154-160 Leicester Street_TP-2022-613 & MPS Amendment

Carlton Residents Association Submission 9 November 2022

Image extracted from Applicant's Town Planning Drawings

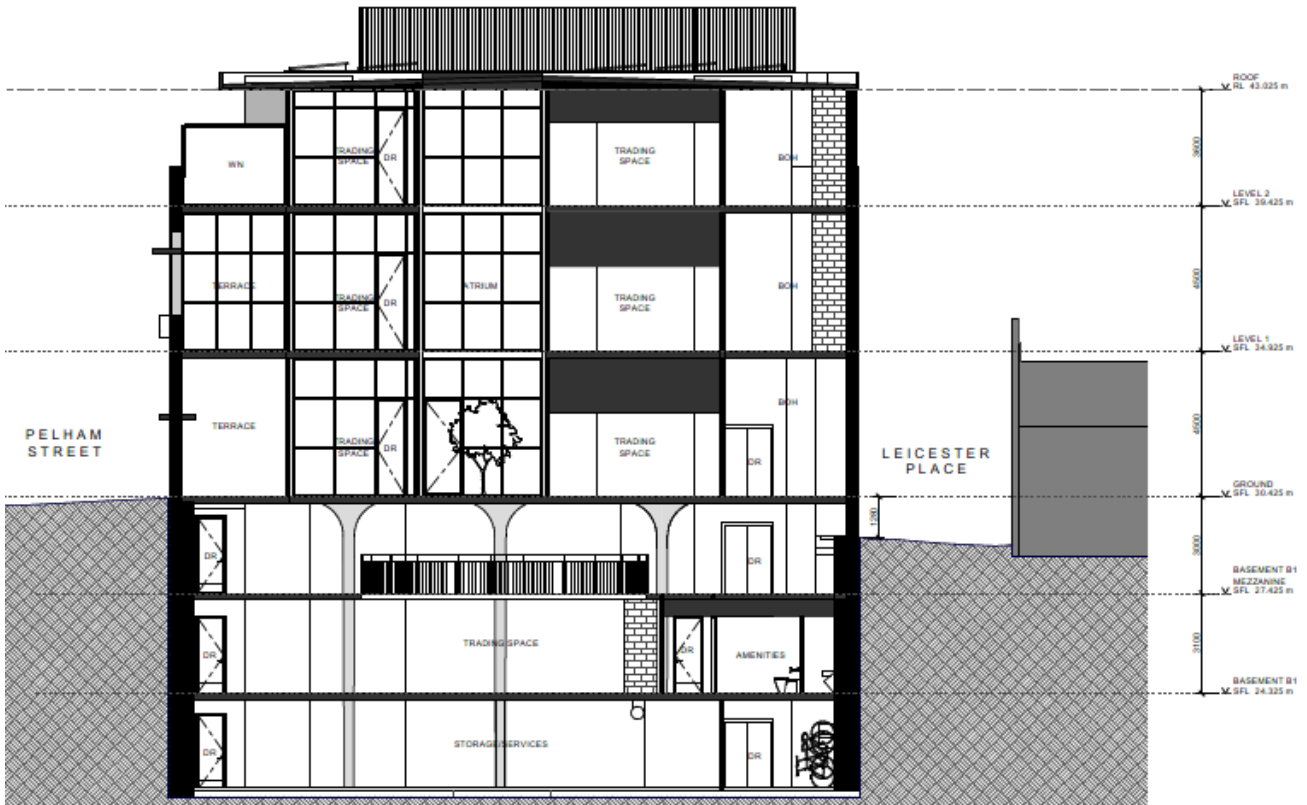
However, in our view, the style and architectural expression is visually DOMINANT. More specifically, the façade treatment is not recessive; the architectural language [both the colour palette and design] is quite flamboyant. In this respect, the design COMPETES for attention with the heritage places to the immediate east and south of the development site. This is NOT appropriate.
